ROSS-WHITING POINTE SUBDIVISION

RESUBDIVISION OF LOT 2

APPLICATION NUMBER 5 DATE July 17, 2014

REQUEST Subdivision

DETAIL SITE PLAN

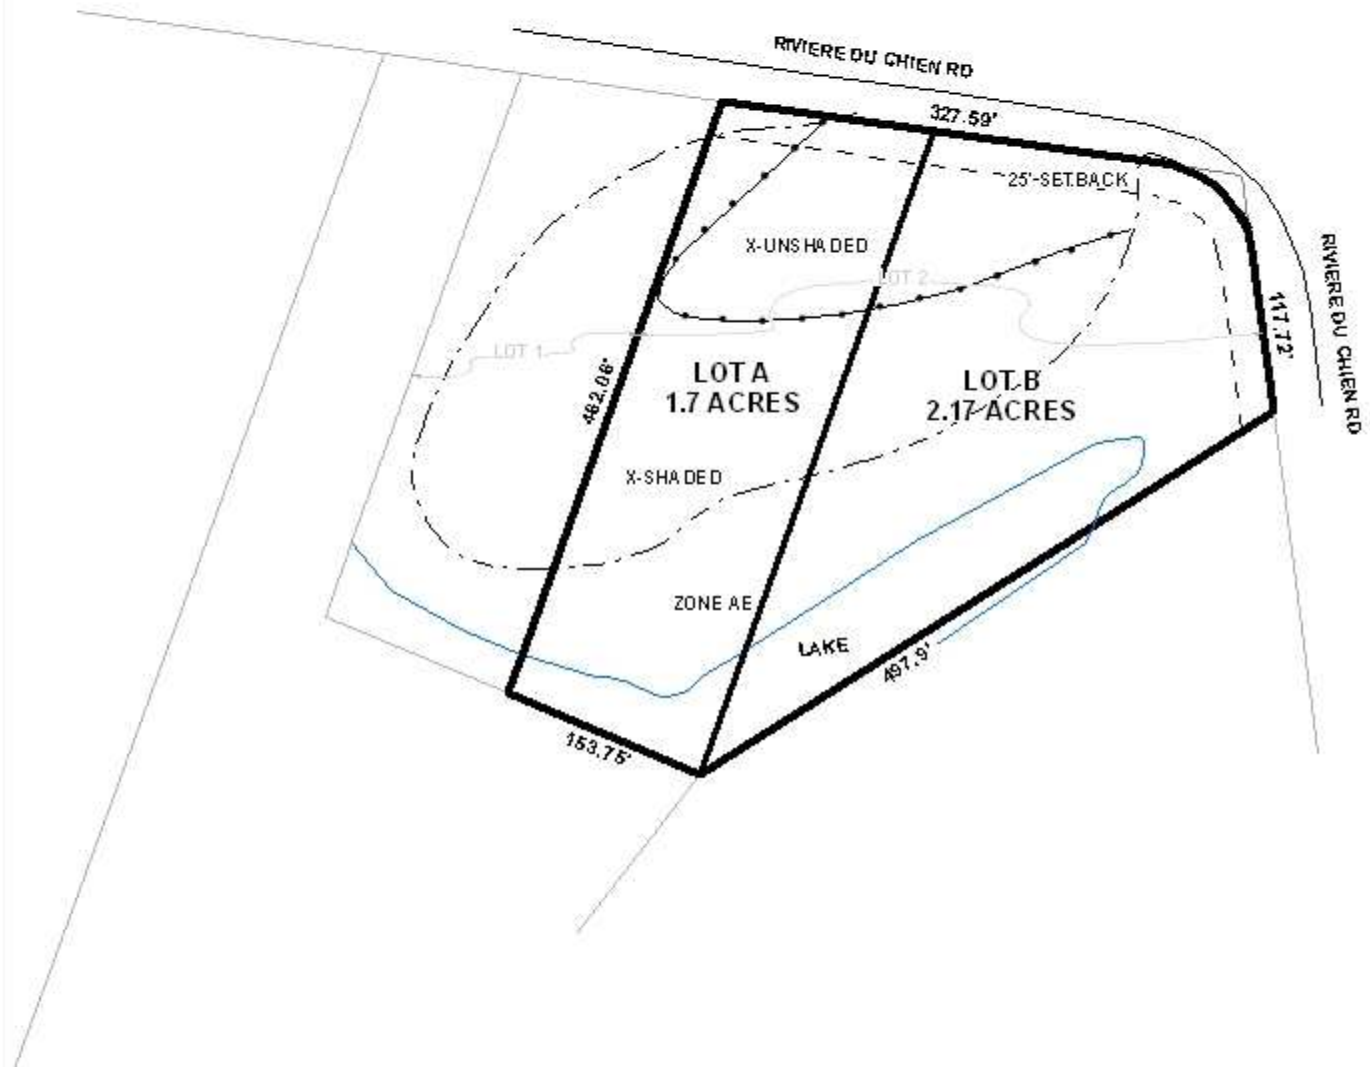
Each lot meets the minimum requirements of the Subdivision Regulations. As on the preliminary plat, the Final Plat should retain the labeling of the lot sizes, or a table should be furnished on the Final Plat providing the same information. The Final Plat should also retain the 25' minimum building setback line.

A note on the preliminary plat states that Lot 2 is limited to two curb cuts. As this is a copy of the note on the original recording of Ross-Whiting Subdivision, this note should be revised for the proposed two lots. As a means of access management, Lot A should be limited to one curb cut and Lot B should be limited to two curb cuts, with the size, location, and design to be approved by Traffic Engineering and conform to AASHTO standards.

It should be noted that the site is located within the X-unshaded, X-shaded and AE flood zones as shown on FEMA Flood Insurance Rate Maps. The site borders on a lake associated with NWI wetlands according to GIS data. The presence of wetlands and floodplains would indicate that the area may be environmentally sensitive; therefore, if approved, the approval of all applicable federal, state and local environmental agencies would be required prior to the issuance of any permits or land disturbance activities. The note on the plat stating such should be retained.

The geographic area defined by the City of Mobile and its planning jurisdiction, including this site, may contain Federally-listed threatened or endangered species as well as protected non-game species. Development of this site must be undertaken in compliance with all local, state and Federal regulations regarding endangered, threatened or otherwise protected species. The note on the plat stating such should be retained.

- 1) retention of the labeling of the lots with their sizes in acres and square feet, or the furnishing of a table on the Final Plat providing the same information;
- 2) retention of the 25' minimum building setback line on the Final Plat;
- 3) revision of the plat note concerning curb cuts to state that Lot A is limited to one curb cut, and Lot B is limited to two curb cuts, with the size, location, and design to be approved by Traffic Engineering and conform to AASHTO standards;

- 4) retention of the note on the Final Plat stating that the approval of all applicable federal, state and local agencies for wetland and floodplain issues would be required prior to the issuance of any permits or land disturbance activities;

- 5) retention of the note on the Final Plat stating that development of this site must be undertaken in compliance with all local, state, and Federal regulations regarding endangered, threatened or otherwise protected species;
